3.0619 - HD #1 Las Palmas Business Historic District

Certificate of Approval – Front Entry-Way Canopy

572 North Indian Canyon Drive

Colony Palms Hotel

B1-A5.0

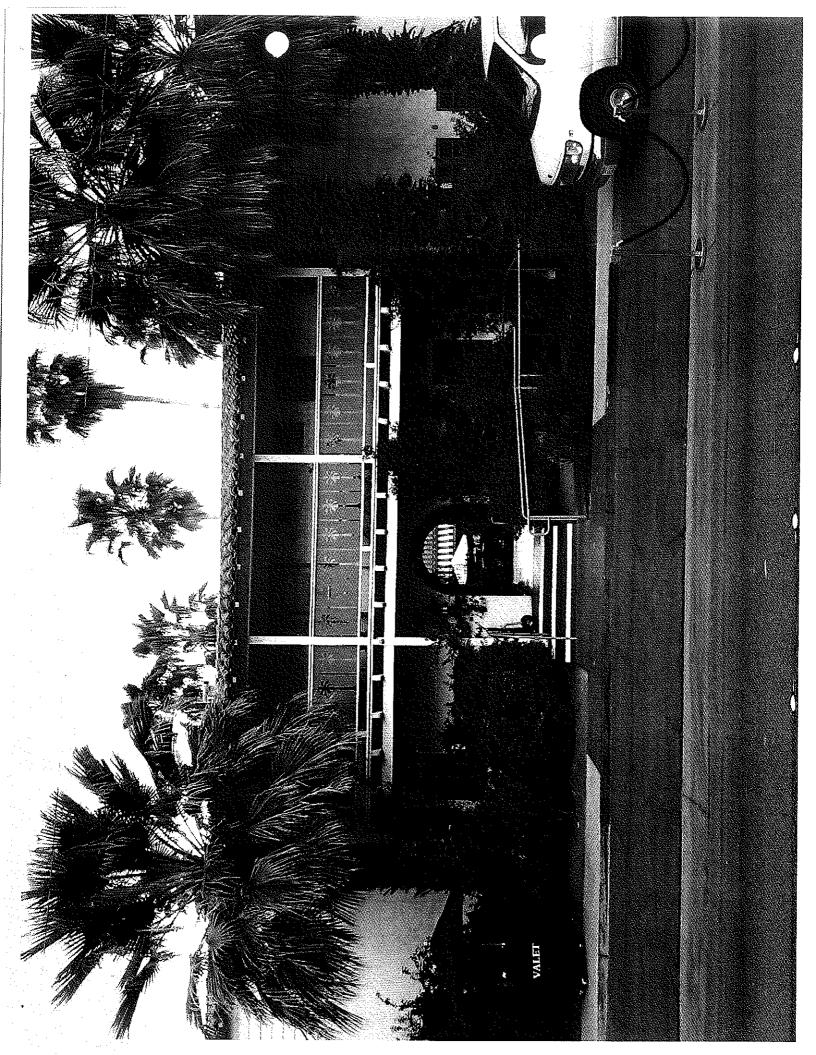
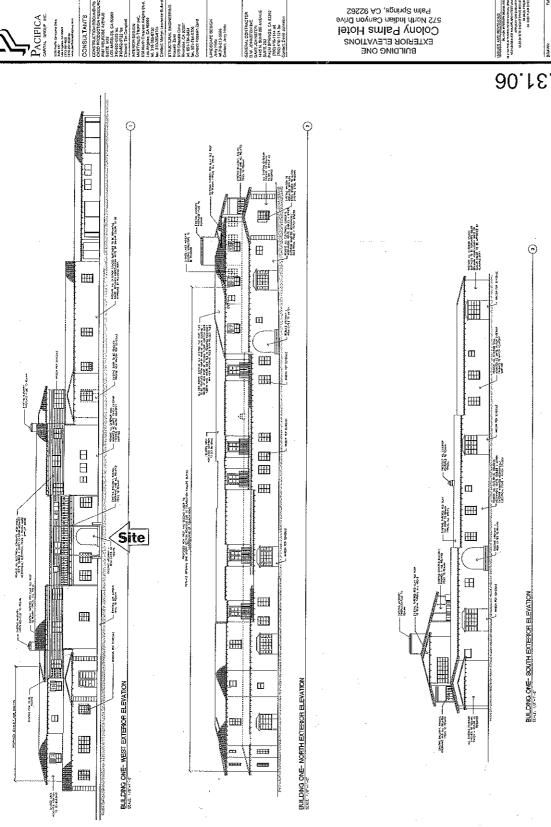
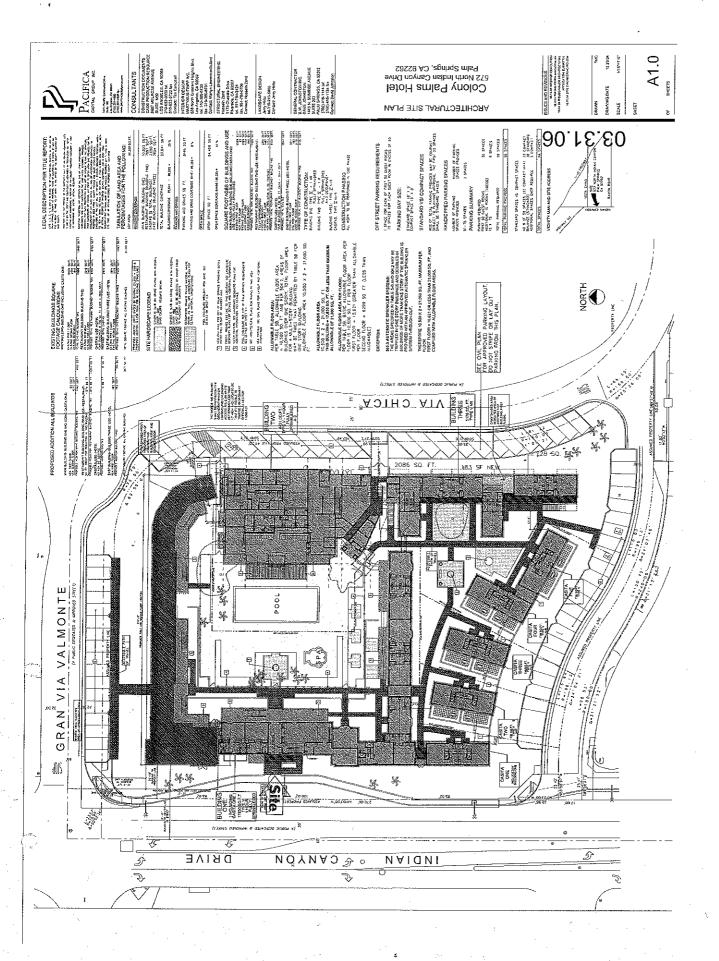
- 1. Canopy is out of scale with existing building. It does not relate to building architecture.
- 2. Look for a landscape solution to provide shade cover and frame the entrance way.
- 3. Questioned the need for the small side panels of the canopy.
- 4. Layout of entry with steps, HD railing, and portal entrance to courtyard are a concern.

- 1. Consider the historic building architectural in the design of the canopy.
- 2. Framework is inappropriate.
- 3. Consider a post and beam style design that will compliment the hotel balcony.

Staff has evaluated this application for the proposed addition of a fabric front entry-way canopy and finds that the canopy design does not enhance the unique architectural elements of the building and does not add value to the surrounding Las Palmas Historic District. The dome shaped canopy is not compatible with the Monterey Revival Style of the building.

The distinctive and unique architectural elements of the Colony Palms Hotel do not relate to the domed shape and style of the proposed canopy. The placement of the structure off-center of the front entry, the treatment of the canopy rear, and the method of attachment to the existing building does not enhance the overall aesthetic look of the property.

The design of the proposed structure does not compliment and is not compatible with the exterior design of the hotel building. The Colony Palms Hotel can be characterized as having elements of a Monterey Revival Style and a dome shaped tubular steel frame does not meet the intent of the finding.

Staff has concluded that the proposed fabric canopy structure is not compatible with the Monterey Revival Style of the building and the applicant should redesign the project based on the comments of the AAC and any comments from the Historic Site Preservation Board.
